Serial No. 10/820,288  
Docket No. VAP023PA (Formerly VSTI-12U)

**Amendments to the Drawings:**

**REMARKS/ARGUMENTS**

FIG. 1

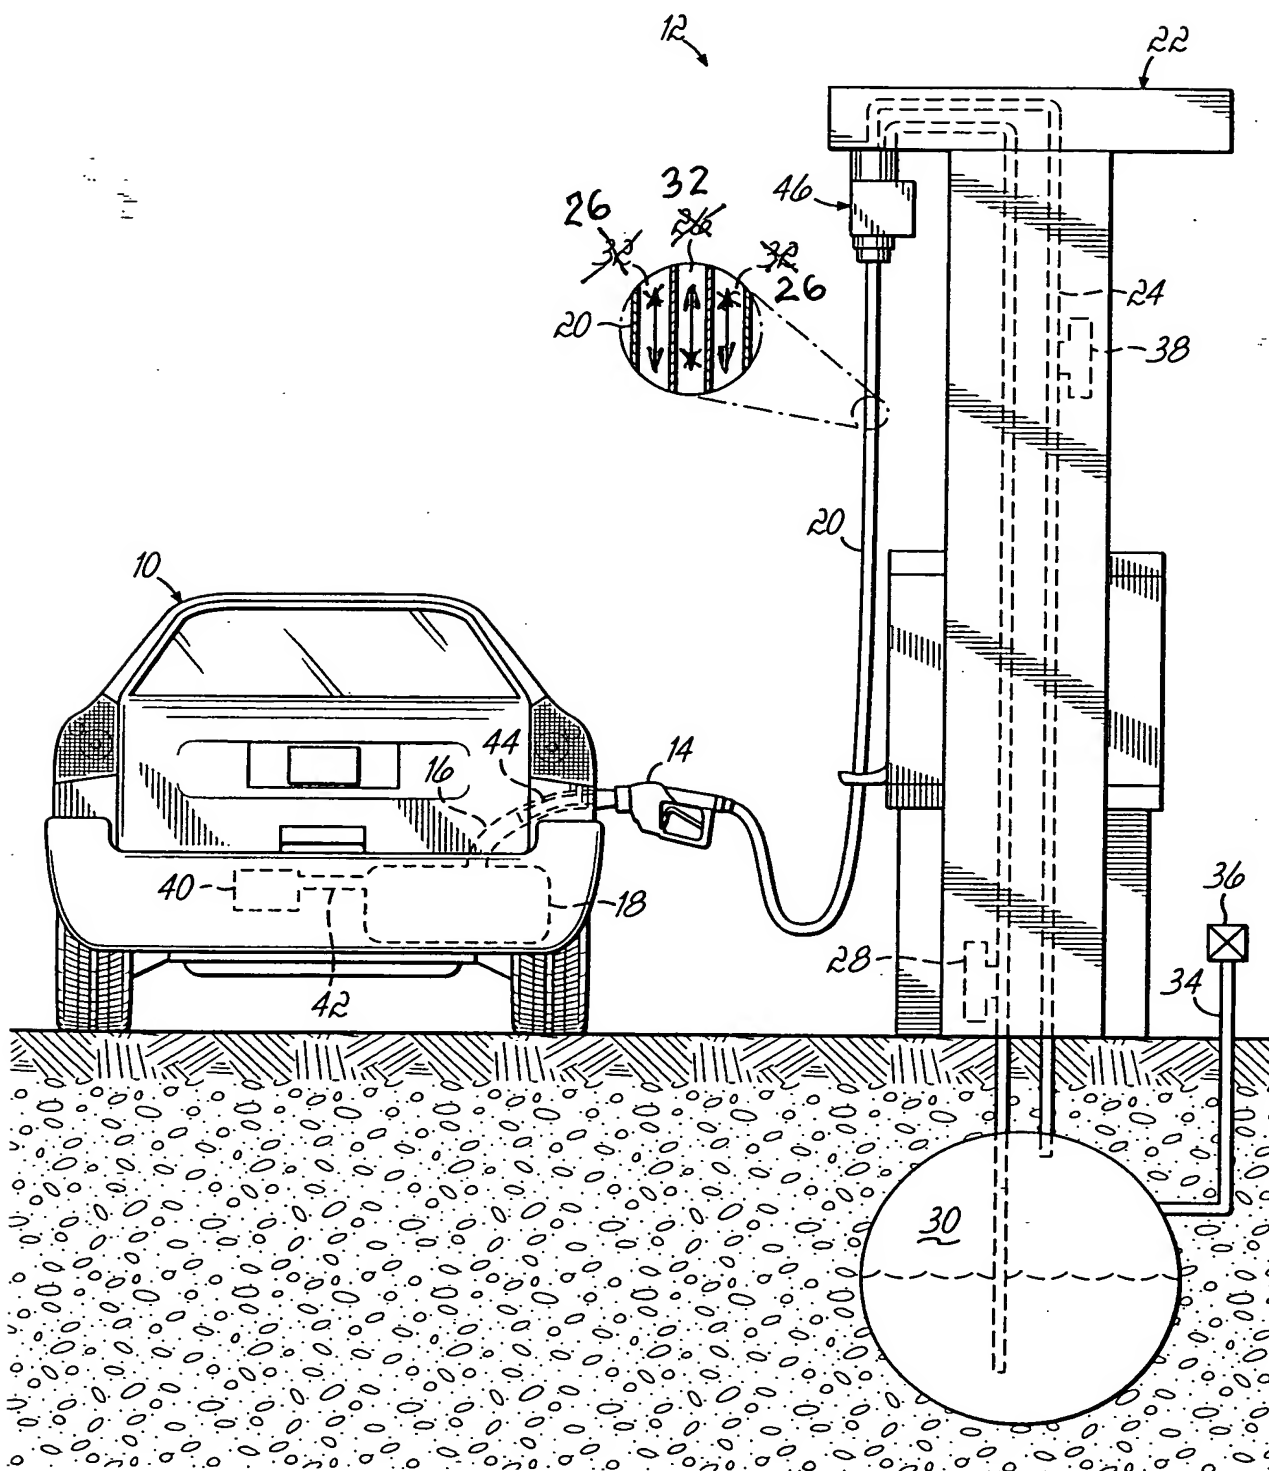
Eight (8) new sheets of formal drawings are enclosed to replace the nine (9) sheets of formal drawings mailed to the Office on April 20, 2004, with Figs. 2A and 2B of previously submitted sheet three (3) being deleted from the present application. For the convenience of the Examiner, also enclosed are copies of previously submitted drawing sheets 1 and 2 having the changes marked in red ink. (Enclosure C). In Fig. 1, the cut-away view of the interior of the fuel delivery hose 20 has been changed to correspond to Fig. 2 and the specification as originally filed to show that the hose 20 has an annular fuel delivery passageway 26 and a central, tubular vapor passage 32. In Fig. 2, the arrow for reference numeral 100 has been redirected to point to the fuel shut-off mechanism; the head of the venturi poppet member 124 has been correctly identified by the reference numeral 126; the extraneous reference numeral 124 over the tandem vapor/fuel control valves has been deleted; and, the reference identifiers associated with the fuel discharge end of the nozzle have been deleted to correspond to the cancellation of Figs. 2A and 2B from the present application.

## ANNOTATED SHEET
